FORTISBC MULTI-YEAR RATE PLAN APPLICATION FOR 2020 TO 2024 EXHIBIT A-4

**Re: FortisBC Energy Inc. and FortisBC Inc. – Multi-Year Rate Plan Application for 2020–2024 –
Project No. 1598996 – Amended Information Request No. 1**

FortisBC Energy Inc. and FortisBC Inc.
Application for Approval of a Multi-Year Rate Plan for 2020 through 2024

INFORMATION REQUEST NO. 1 TO FORTISBC

Figure C4-2: Proportions of Transmission and Distribution Approaching Life Expectancy

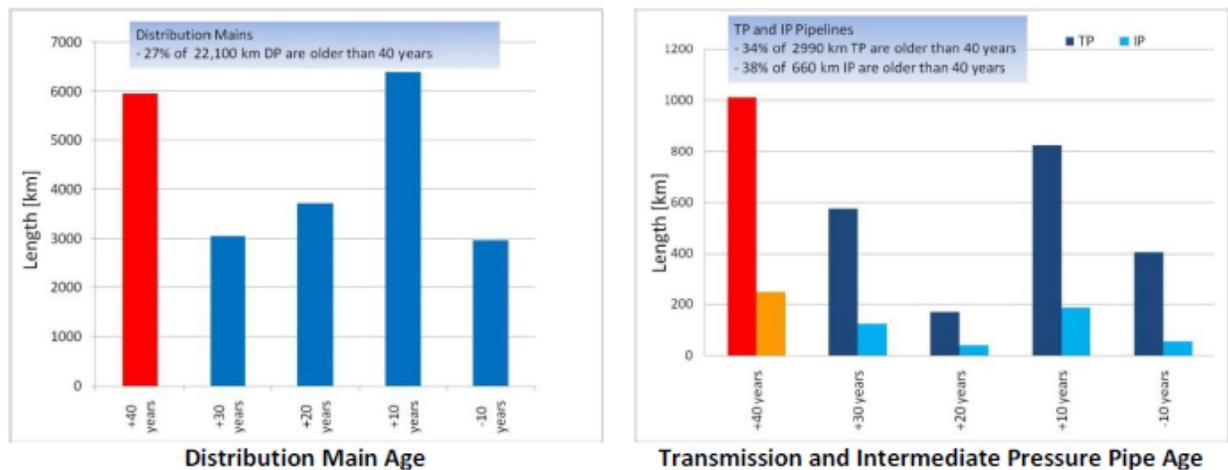
- 47.1 Please update the above figure for current asset conditions.

Figure C6-4: Innovation Gaps to be Addressed by the Fund

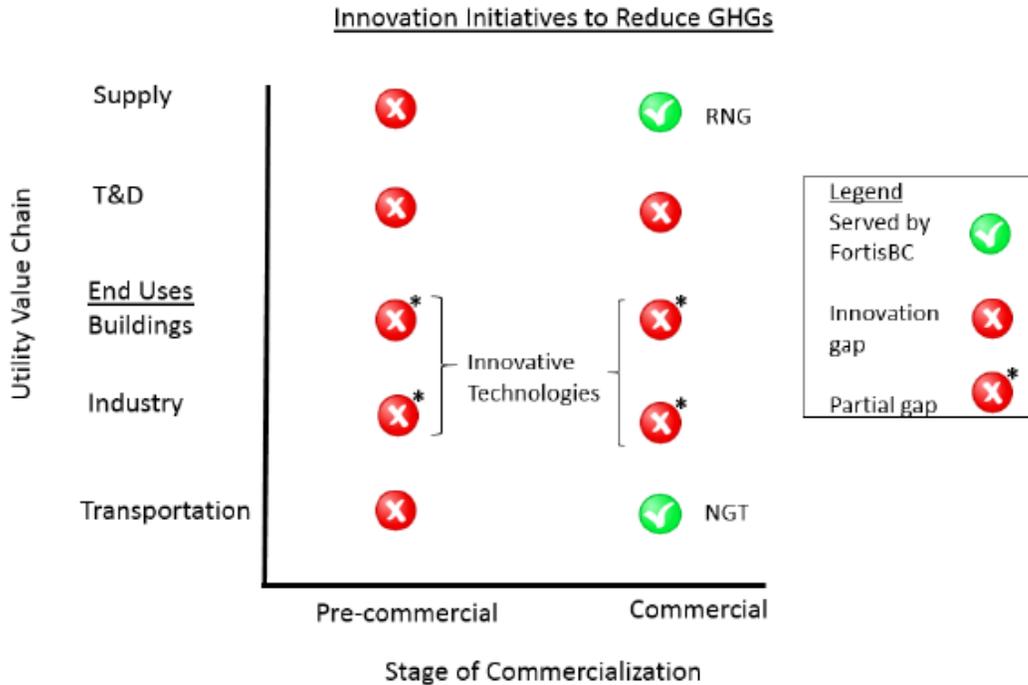
70.1 With reference to the innovation gaps (and partial gaps) identified in Figure C6-4 of the Application, please provide a breakdown and description of the initiatives for which FortisBC intends to utilize the annual \$4.9 million (FEI) and \$0.5 million (FBC) on during the proposed MRP term to address the identified “gaps”.

Figure D5-1: 2018 Corporate Services Study Organizational Chart

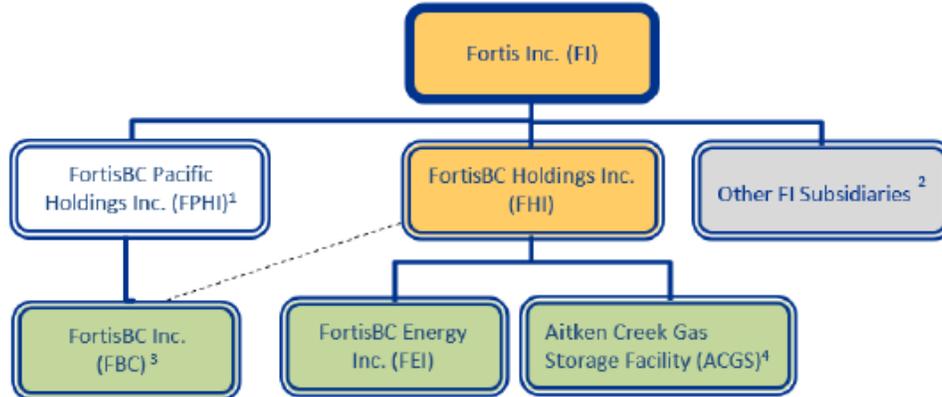
On pages D-42 to D-43 of the Application, FortisBC states that one of the changes included in the 2018 Corporate Services Study as compared to the 2013 Corporate Services Study is that ACGS and FBC have been added to the sharing methodology of FI and FHI corporate services costs. FI and FHI have previously been directly charging ACGS and FBC for the corporate services provided.
